TRAULSEN TECHNICAL BULLETIN

DANFOSS SPINDLE RETROFIT TO BACK OF CABINET

Figure 2

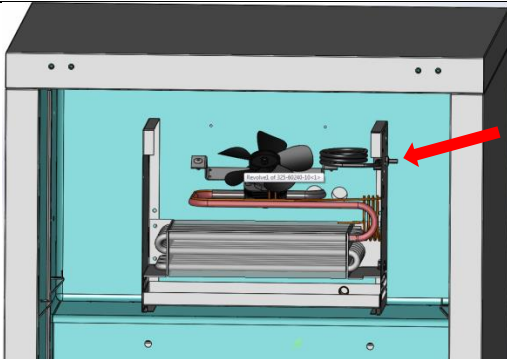
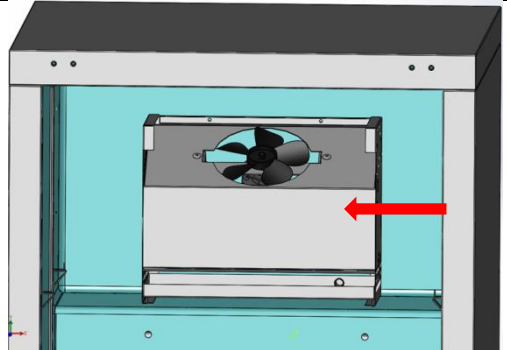
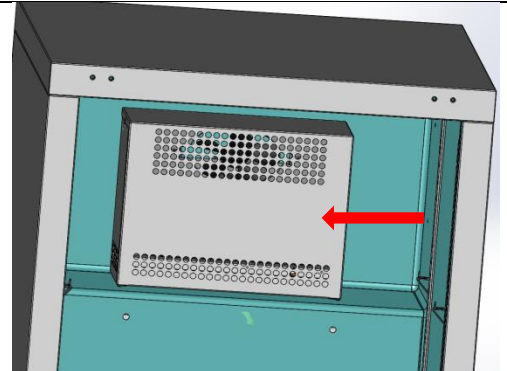
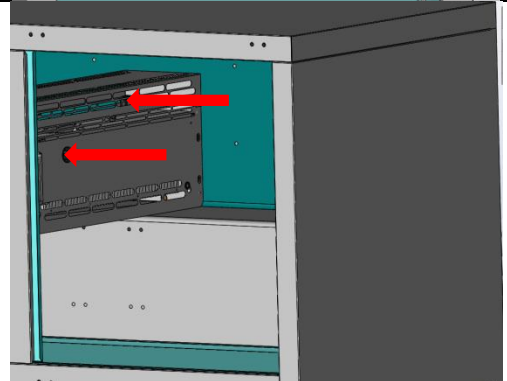
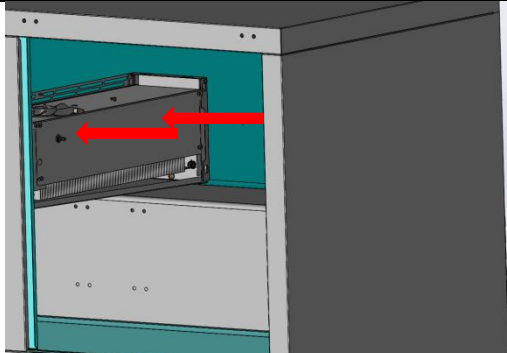
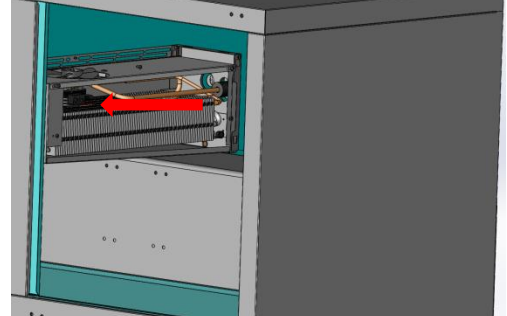
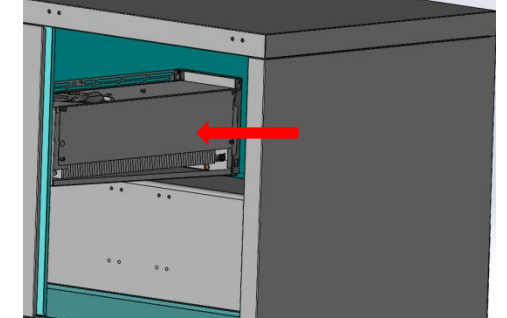
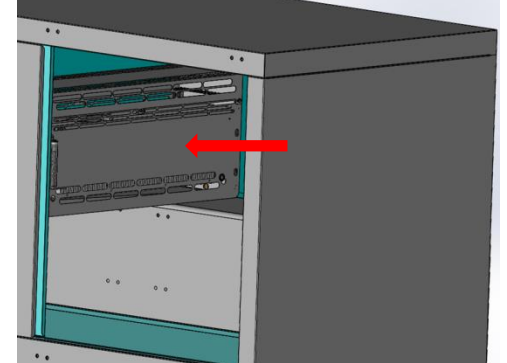
Figure 2 will demonstrate how to install the spindle on the back of the cabinet.

<p>Remove the toggle switch and bracket.</p>	
<p>Install the new spindle and toggle switch on the new bracket.</p> <p>Install the bracket in the same location as the other bracket.</p>	
<p>Plug the new spindle into S3 location on the Danfoss control.</p>	
<p>Install the back cover.</p>

Figure 1

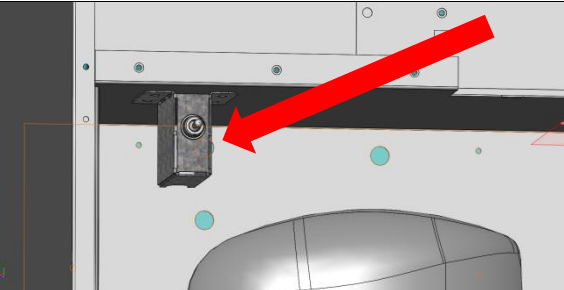
Figure 1 will demonstrate how to remove the spindle from inside the cabinet.

<p>Turn off cabinet and unplug power cord.</p>	
<p>Remove screws from the back cover.</p>	
<p>Unplug spindle form S3 location on Danfoss control.</p>	
<p>Pull out hand knob and remove sensor and cover. (CUC 27/32).</p>	
<p>Remove panel. (CUC 27/32).</p>

<p>Remove spindle nut and pull spindle from cabinet (Removal of zip ties may be needed CUC 27/32).</p>	
<p>Install panel back into place. (CUC 27/32).</p>	
<p>Install panel back into place. (CUC 27/32).</p>	
<p>Pull out hand knob, remove sensor and covers. (CUC 48/60/72).</p>

<p>Remove baffle cover and spindle nut. (CUC 48/60/72).</p>	
<p>Pull out spindle from cabinet. (Removal of zip ties may be needed CUC 48/60/72).</p>	
<p>Install the baffle cover. (CUC 48/60/72).</p>	
<p>Install the covers. (CUC 48/60/72).</p>
